Product Change Notification

Impel/Impel Plus Series 172730/171990

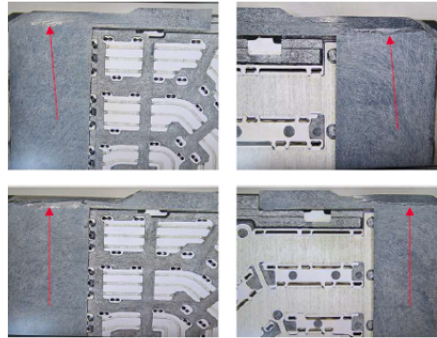
Damage of housing surfaces observed at sides of connector caused by abrasion with tray

Addition of pink foams at sides to prevent abrasion of housing with tray
